Remarks

Objection to the Drawings

Fig.1
(PRIOR ART)

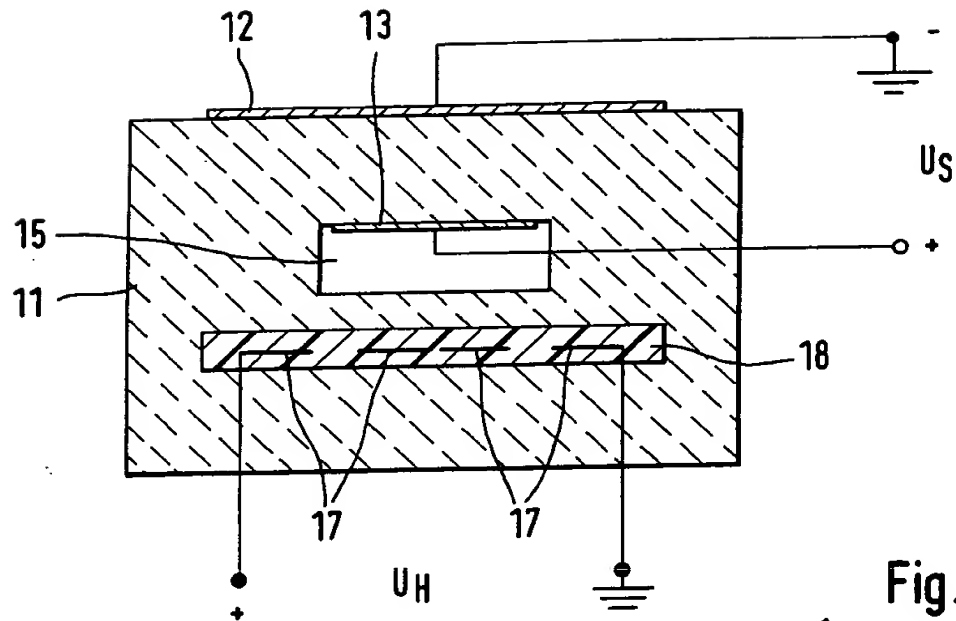
The drawings were objected to because Fig. 1, was not labeled "Prior Art" and the reference sign "U_B" was not included, and the Examiner had requested that appropriate correction should be made to the figures. The Applicant is herewith submitting a red-lined drawing with the requested correction. Therefore, the applicant respectfully requests that the Examiner kindly withdraw the objection to the drawings.
